CNL-13-126

Browns Ferry Nuclear Plant Units 1, 2, and 3  
Renewed Facility Operating License Nos. DPR-33, DPR-52, and DPR-68  
NRC Docket Nos. 50-259, 50-260, and 50-296

**Subject: Browns Ferry Nuclear Plant, Units 1, 2, and 3 - Proposed Technical Specification Change To Revise The Leakage Rate Through MSIVs - TS-485**

**Alternate Leakage Treatment (ALT) Pathway**

Figure 1

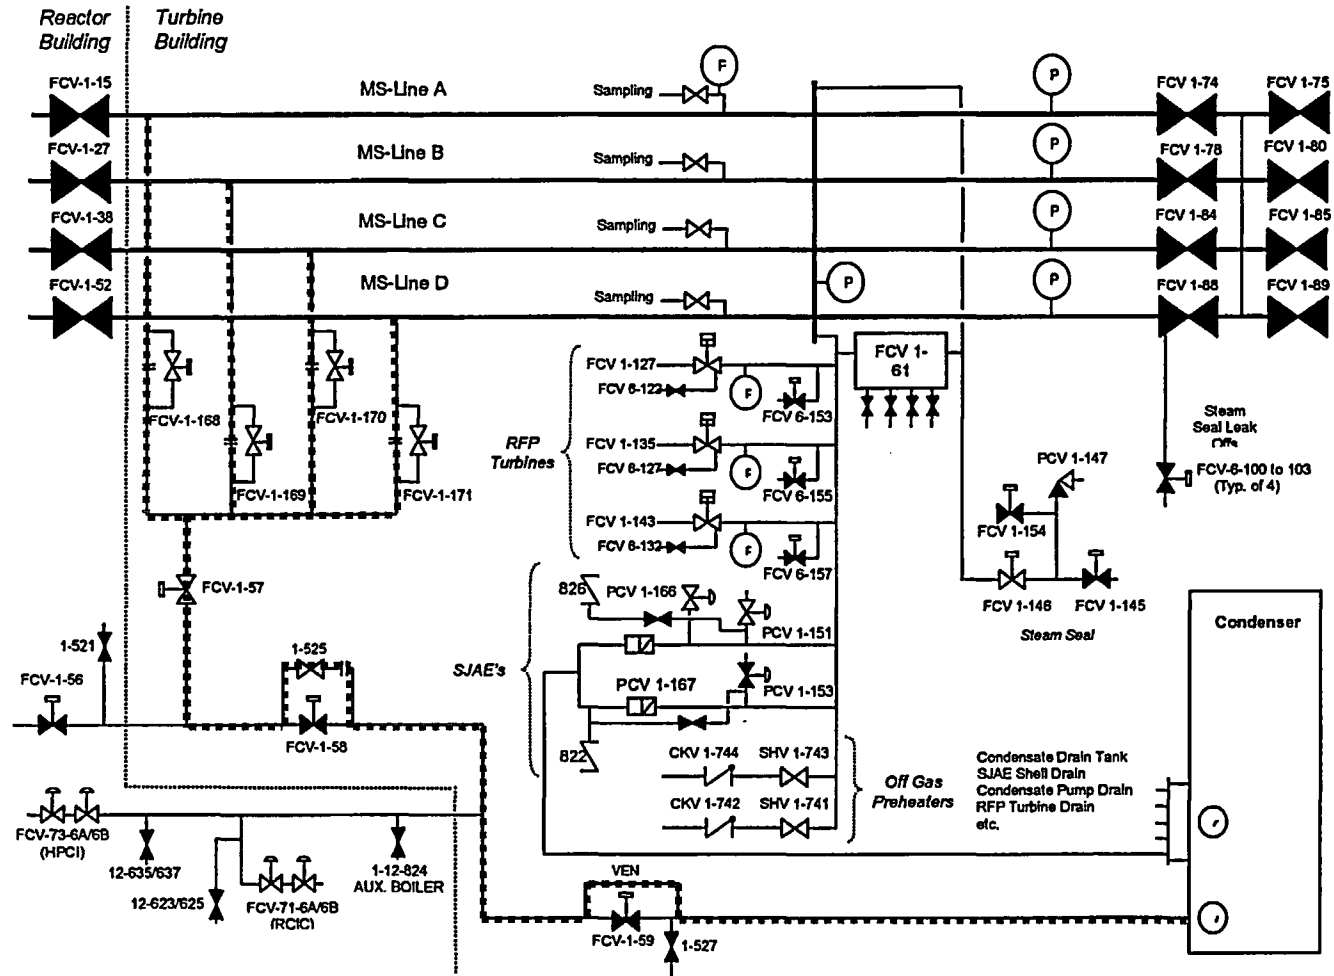
TVA proposes to continue to utilize the main steam drain lines to preferentially direct MSIV leakage to the main condenser. However, to resolve issues identified in the 10 CFR 50.9(b) notification associated with the ALT Pathways, the primary ALT Pathway (Figure 1) will be defined as the passive pathway through the orifice bypass lines around each of the main steam drain lines, through open valve FCV-1-57, through the orifice bypass line around valve FCV-1-58, and finally through a non-orifice bypass line around valve FCV-1-59 to the condenser. To support the use of this passive pathway, the dose analysis has been re-performed assuming reduced MSIV leakage rates of 60 scfh maximum through each MSIV and 85 scfh for the combined leakage rate for all four main steam lines. The secondary ALT Pathway (Figure 2) has now been defined as the

The primary ALT Pathway is based on the flow path through the orifice bypass lines around each of the main steam drain lines, through open valve FCV-1-57 (which will have its power removed), through the 0.1875-inch orifice bypass line around valve FCV-1-58 and the four inch bypass line around FCV-1-59 for those events taking credit for the availability of the ALT Pathway to the condenser. The primary flow path from the MSIVs to the condenser continues to be passive, requiring no operator actions or valve positions to change to establish the pathway. This primary flow path consists of the following:

- Four outboard MSIVs through 24- inch lines connecting to two-inch drain lines from each MSIV.
- Four two-inch bypass lines, that contain 0.25-inch orifices (around valves FCV-1-168, FCV-1-169, FCV-1-170 and FCV-1-171), connecting to a three-inch header.
- The three-inch header through normally open, with power removed, valve FCV-1-57 to a three-inch tee.
- The three-inch tee through a one-inch bypass line (around the normally closed valve FCV-1-58) that has a 0.1875-inch orifice and a normally open manual blowdown valve (BOV)-525.
- A four-inch bypass line (around normally closed valve FCV-1-59) to the condenser.

Figure 2

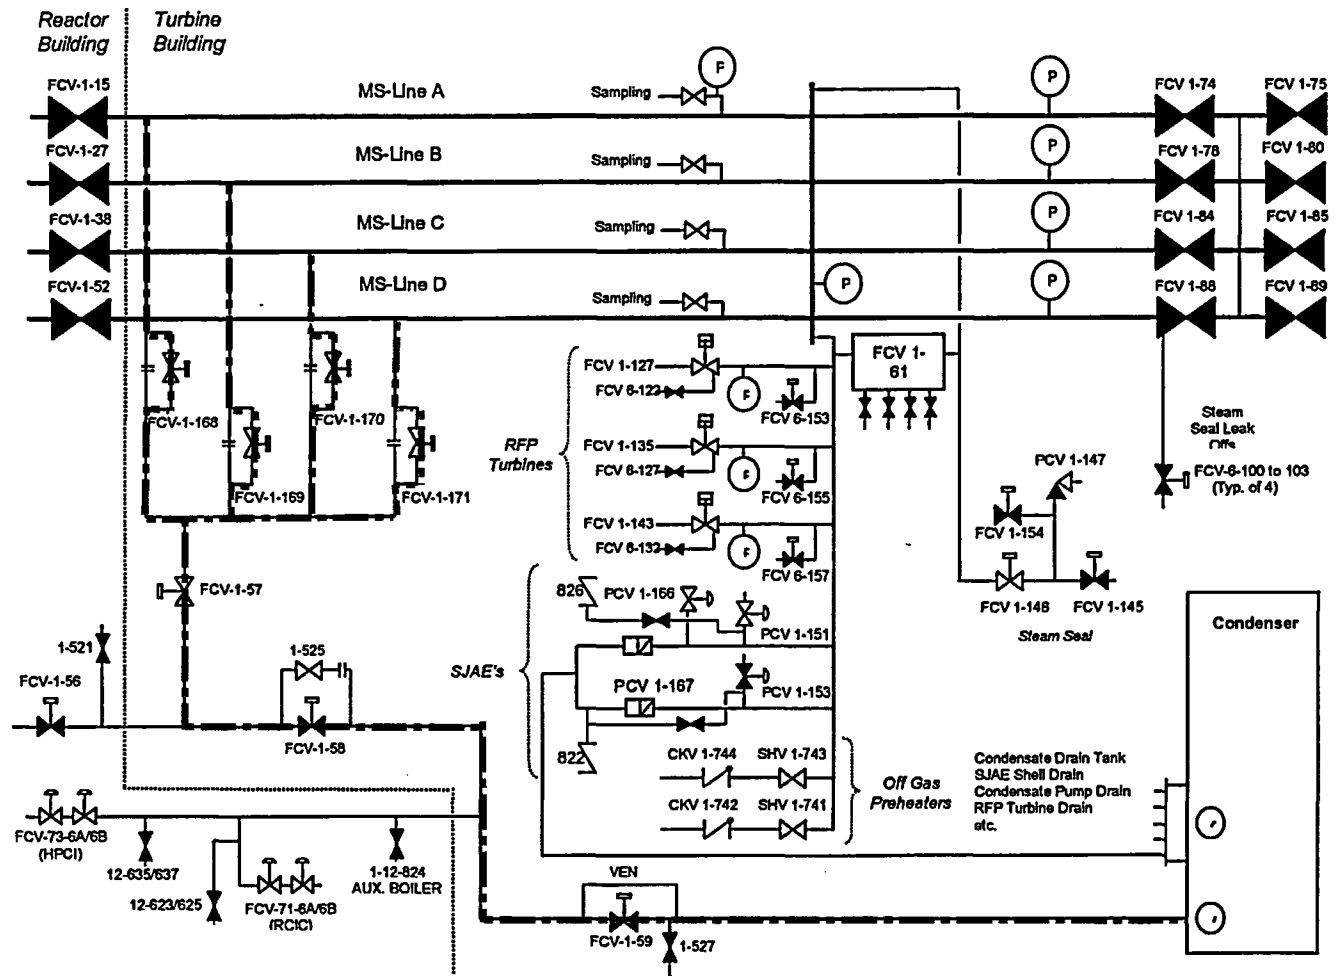
pathway through the main steam drain lines and through open valves FCV-1-57, FCV-1-58, and FCV-1-59 to the condenser.

In the unlikely event the primary flow path is not available, and consistent with the guidance provided in NEDC-31858P, a secondary flow path is provided (although not with orifice flow). The secondary flow path is through normally open valves FCV-1-168, FCV-1-169, FCV-1-170, and FCV-1-171, and continues through valves FCV-1-57, FCV-1-58, and FCV-1-59 to the main condenser.
